NOTICE UNDER SECTION 96 (1) CHAPTER IX OF THE BOMBAY
DISTRICT MUNICIPAL ACT III OF 1901 AS MODIFIED
UPTO THE 1st MARCH 1915.

PLAN OF PROPOSED BUILDING ON
PLOT NO 87 & 88 SHEET NO 5 O.L.B. 2.

REFERENCE No. B. S. P. 340 OF 1932

REFERENCE No. L.M.A.B.S. P. 340 OF 1932.

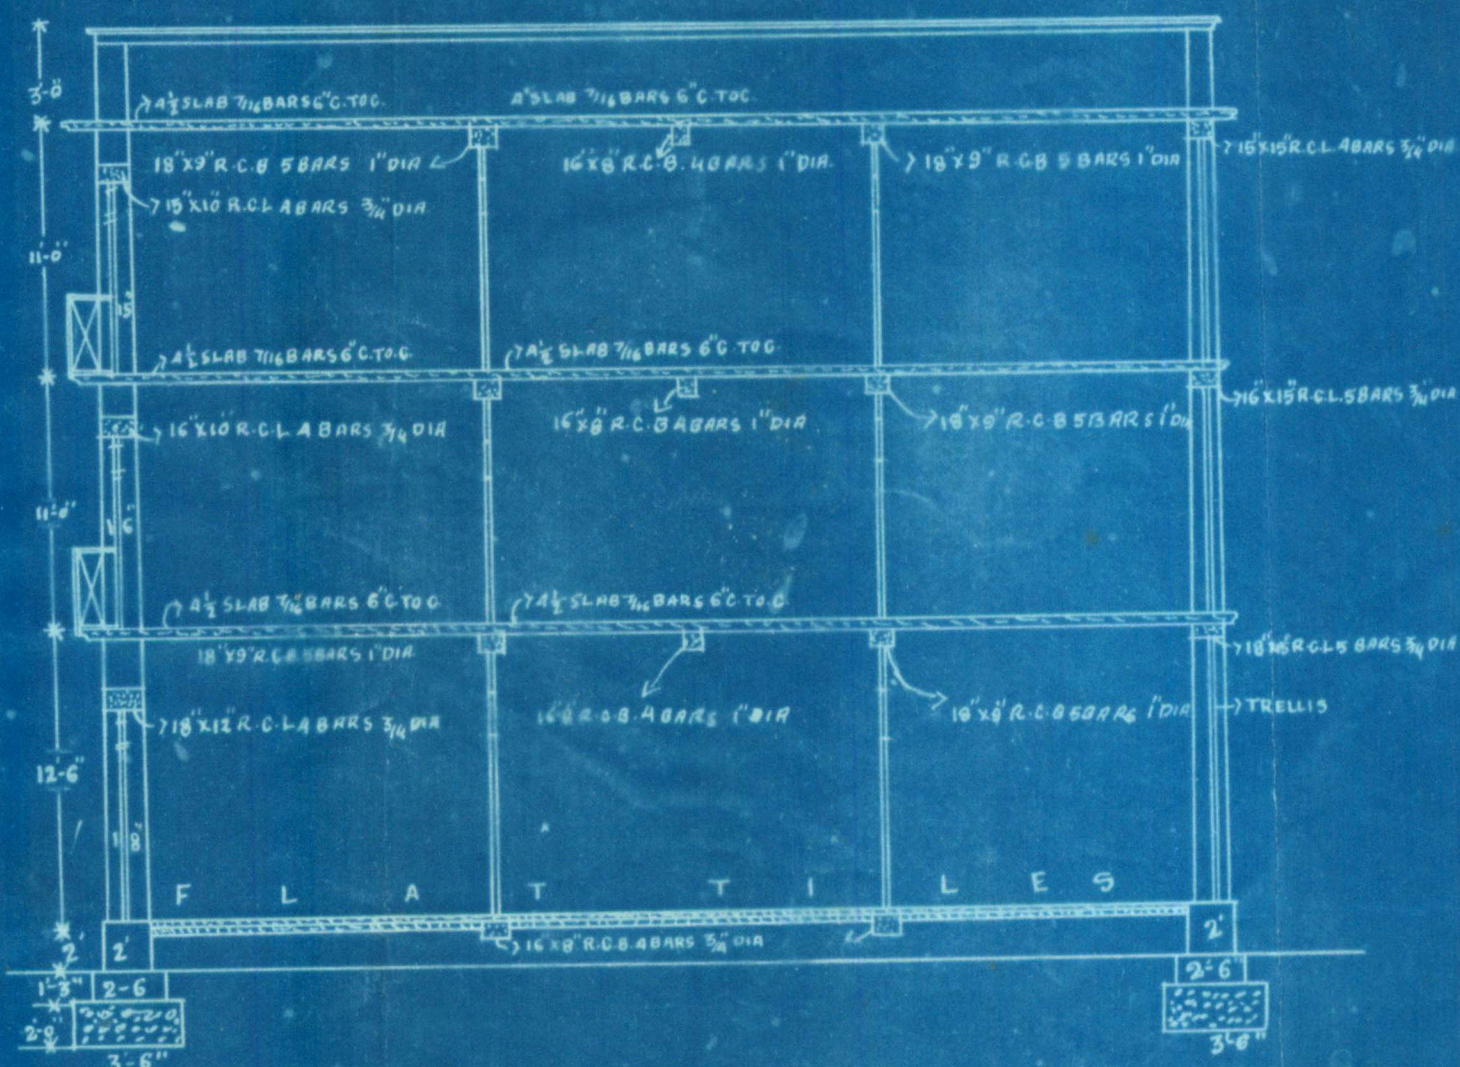
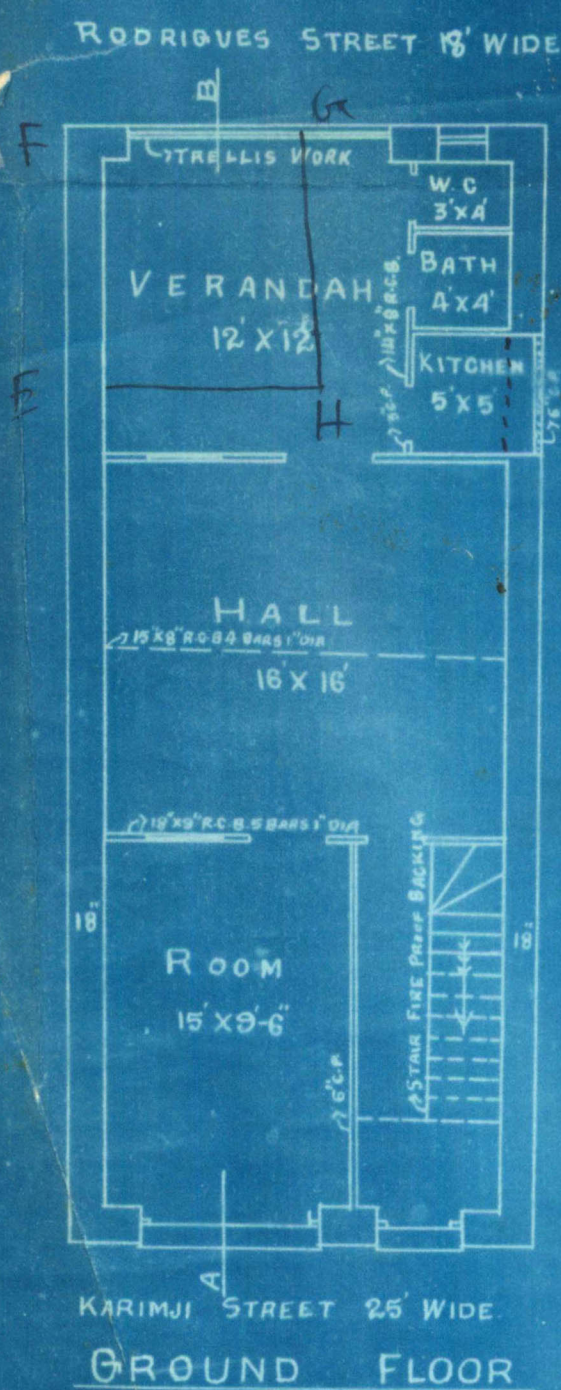
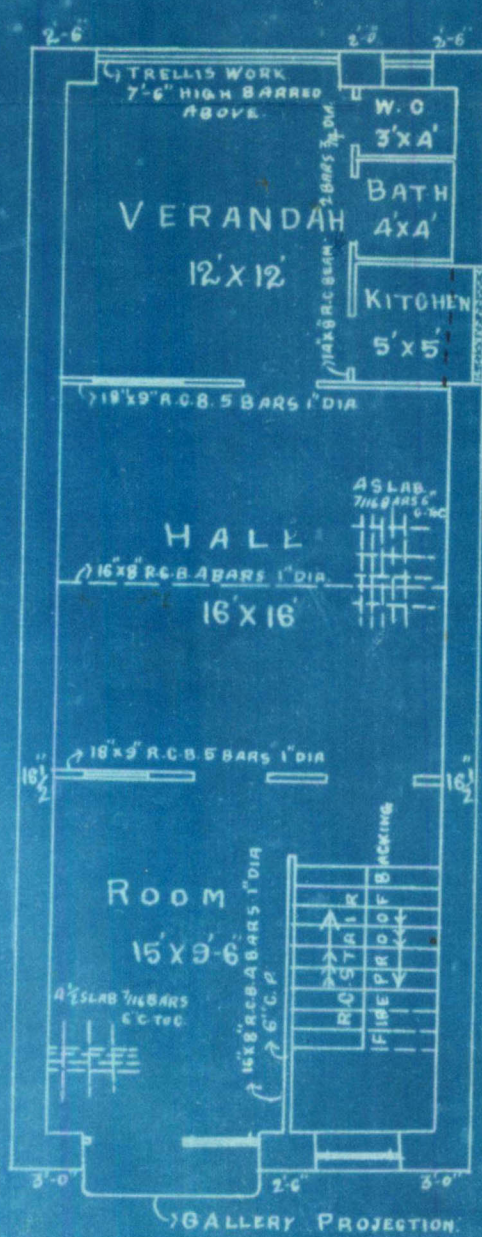
BSS's other plan shown aligned StateEF&H must be 17/1

PLAN OF PROPOSED BUILDING ON

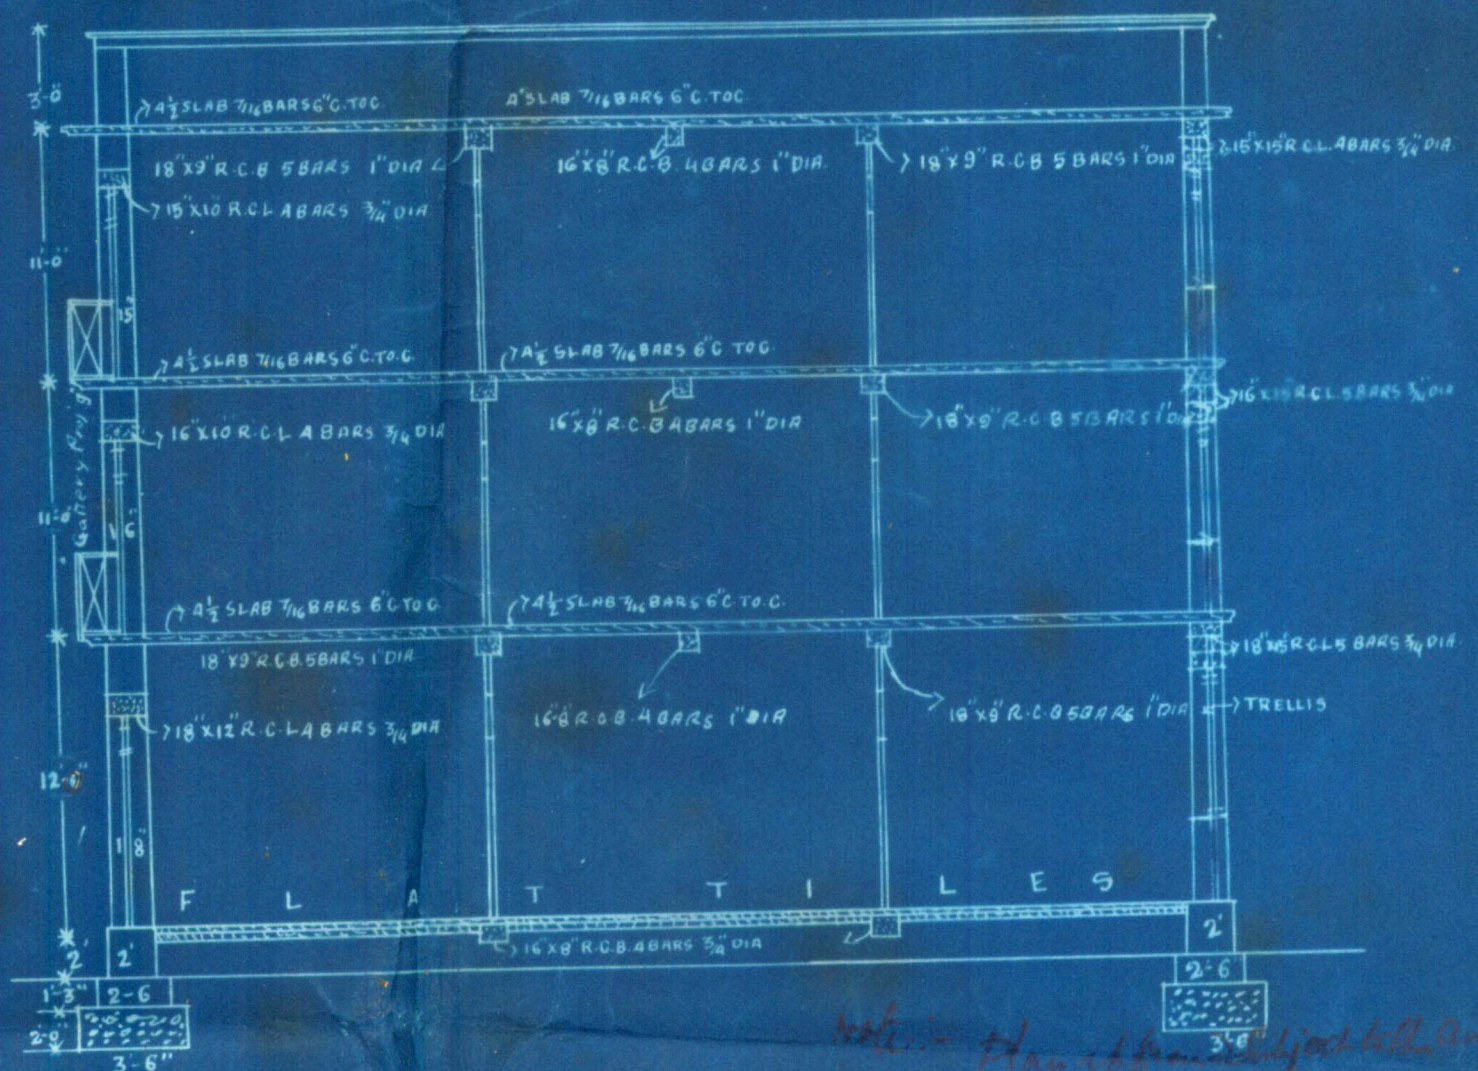
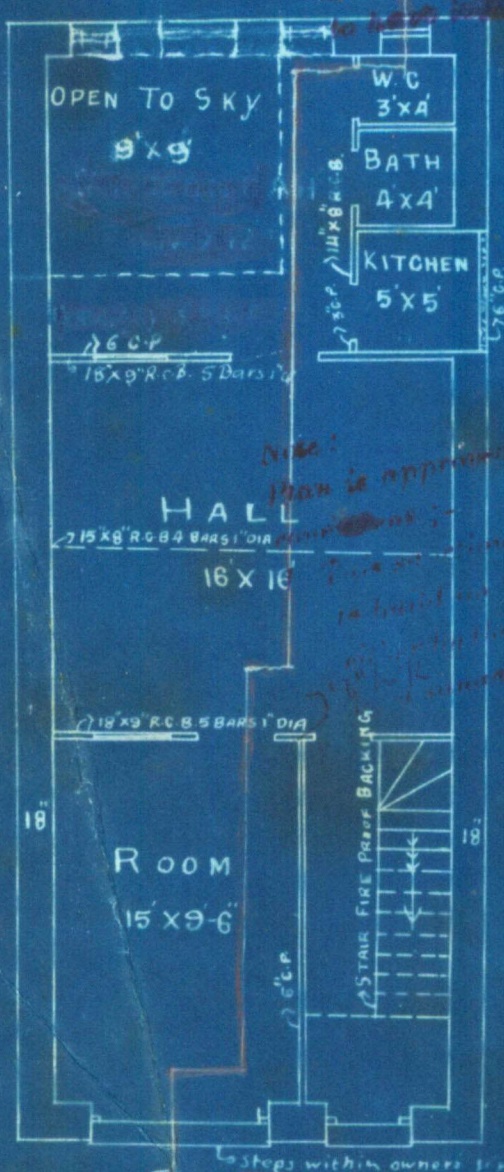
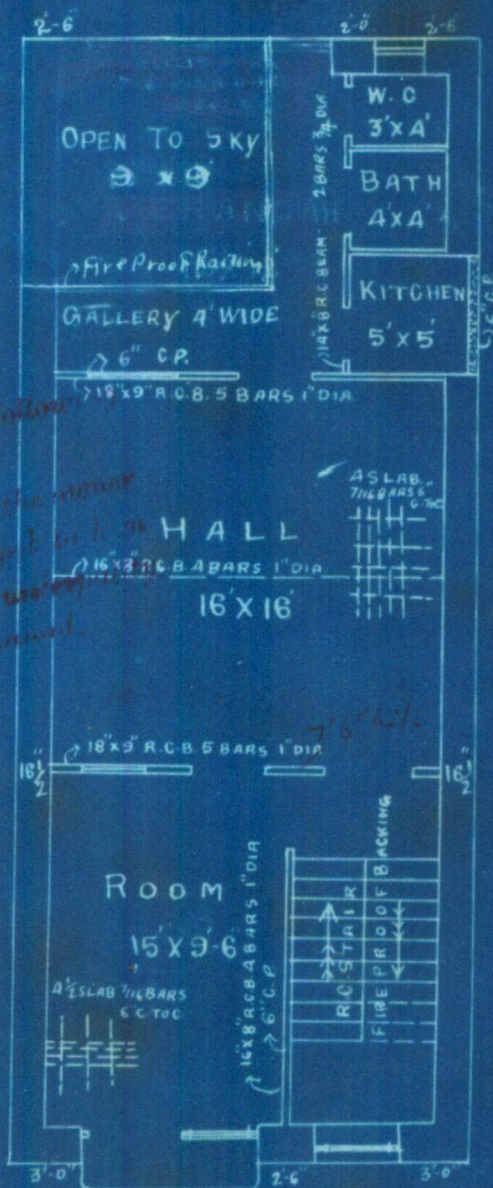
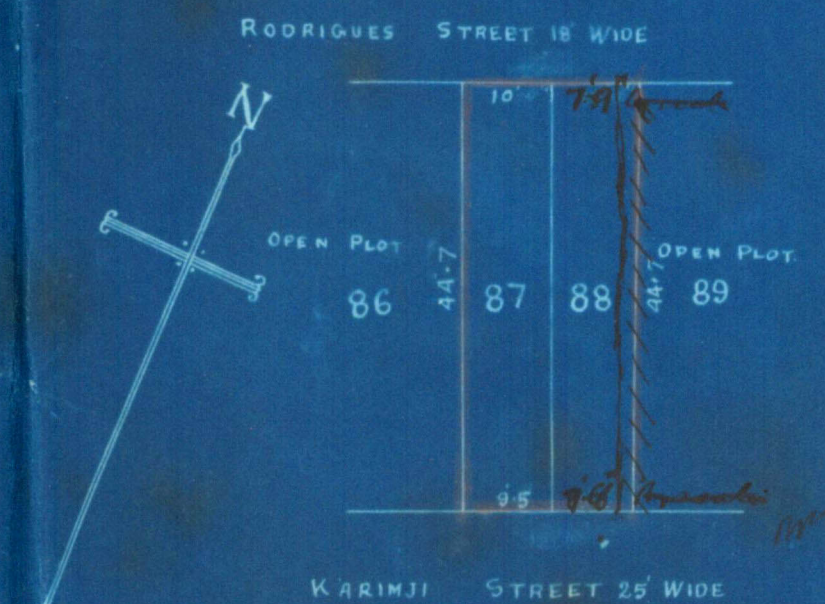
Steps have been provided in the owner's name.For the verandah only 3' high and
truller work above can be allowed.Lintel over the kitchen should be fromPlans shall be kept pendinguntil amendmentsare sanctioned.1577

- (1) Steps must be provided in the owner's own limit
- (2) For the Verandah only 3' Solid & trellis work
where can be allowed.
- (3) Lintel over the kitchen should be shaded
- (4) Plan shall be kept pending until amalgam
has been sanctioned
- (5) E F G H must be left open
